RE: RESPONSE TO REQUEST FOR FURTHER INFORMATION IN RELATION TO PROPOSED DISCOUNT FOODSTORE ANCHORED DEVELOPMENT AT MAIN STREET UPPER, NEWCASTLE, CO. DUBLIN

SOUTH DUBLIN COUNTY COUNCIL REG. REF: SD22A/0312

Figure 1: LAP Movement Framework

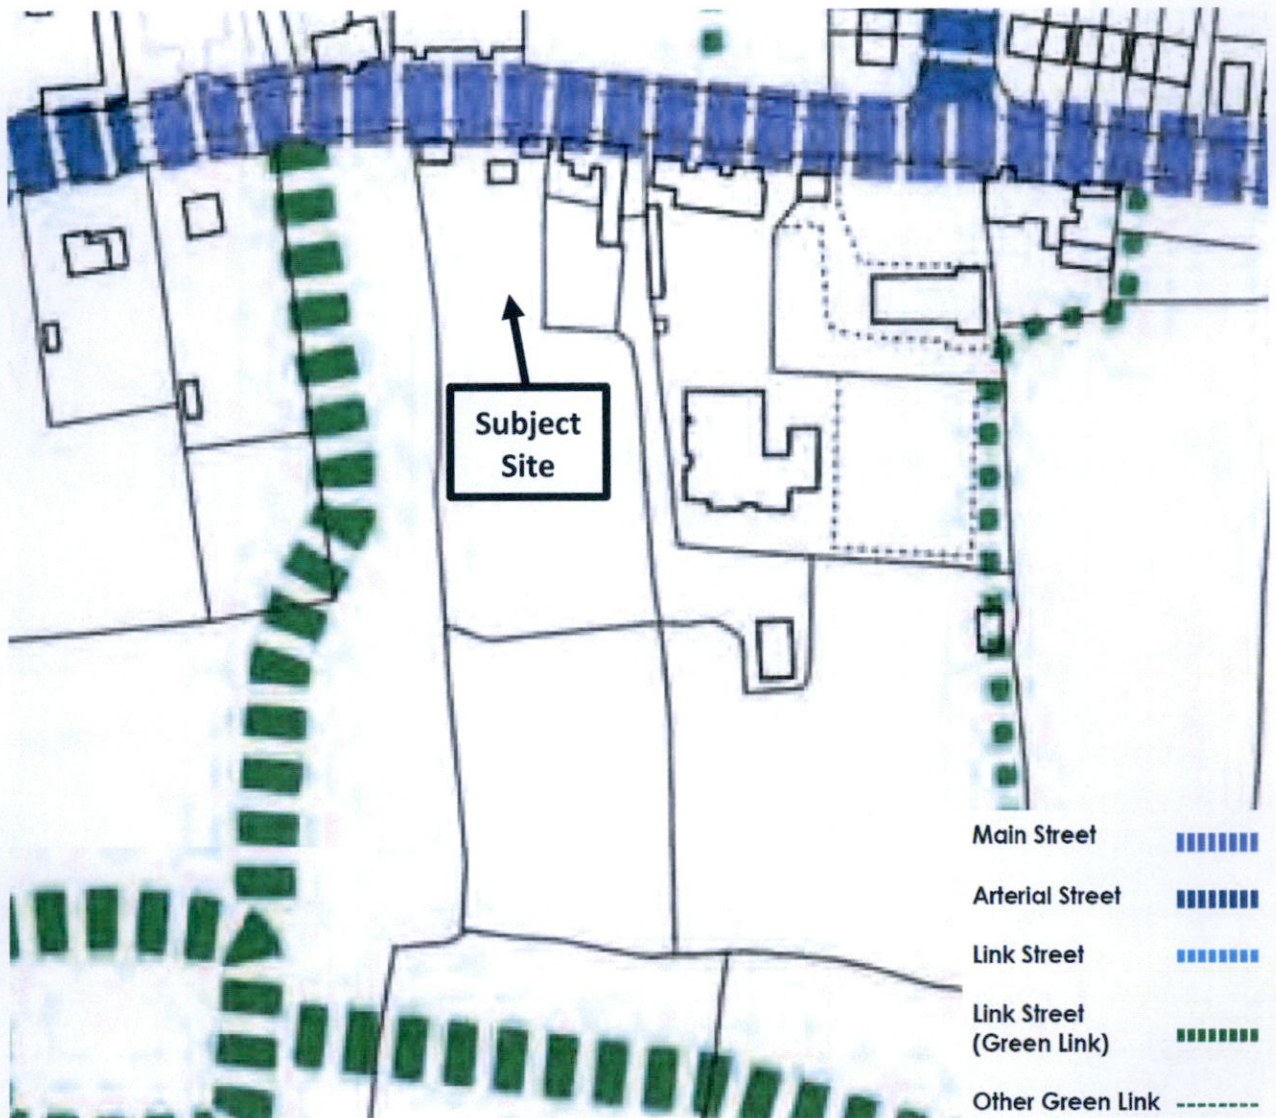
"1. The Applicant is requested to revise the design and layout of the proposed development, providing a complete set of site layout plan, floorplan, elevational, sectional and cross-sectional drawings to address the following: (i) The provision of a pedestrian/cycle link running along the western boundary of the subject site in a north-south direction.

For instance, the existing Local Area Plan (LAP) illustrates that the primary through linkages, for all modes including pedestrian / cyclists, is via the corridor to the west (i.e. St. Finian's Way), as illustrated in Figures 1-3 below and where we note the LAP states (in Section 5.4) that: "*Pedestrian and cycle routes shall be provided in accordance with the street typologies and cross sections illustrated in Appendix 3 to include for the provision of cycle and pedestrian paths/tracks on both sides of most street types. Access Streets shall be designed for speeds conducive to shared pedestrian, cycle and vehicular movements. (Objective AM5)*" [Our Emphasis]

Figure 5: 10 Metre Buffer from the Site Boundary (Dotted Blue Line)

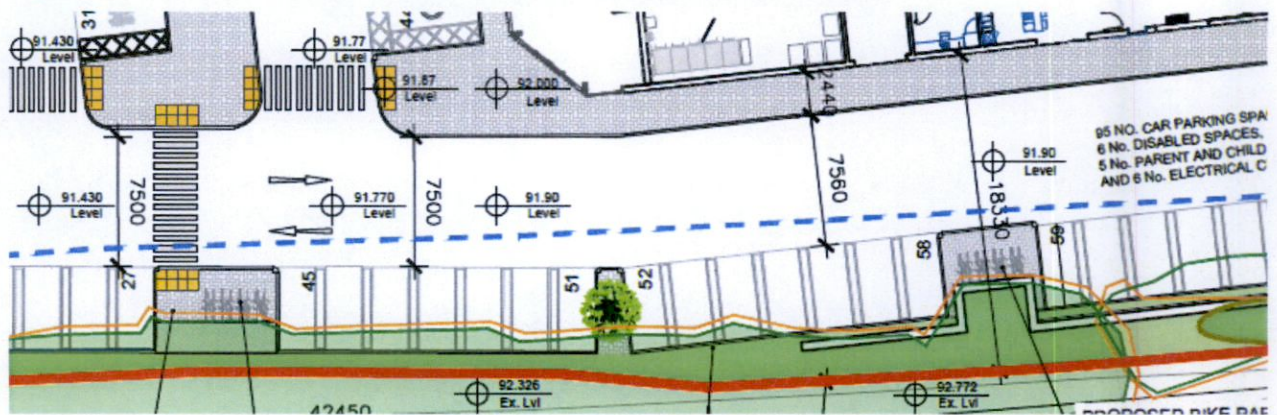
"8. The development encroaches on burgage (heritage) hedgerow along the western boundary and proposed to remove sections for future links. A 10m setback from the watercourse is required on the western boundary. This 10m riparian zone should incorporate native hedgerow planting to enhance the existing heritage hedgerow. The proposals should be revised to, where possible eliminate or at the very least minimise the need to remove Burgage boundary hedgerow for future links. The Applicant is requested to provide revised site layout plan, plan, elevational and sectional drawings accordingly."

Figure 5 below illustrates for context the outline of a 10 metre buffer from the site boundary (as opposed to the watercourse / ditch) which would vary in outline. This illustrates the severity of the impact of such a buffer, even using the site boundary as a baseline.
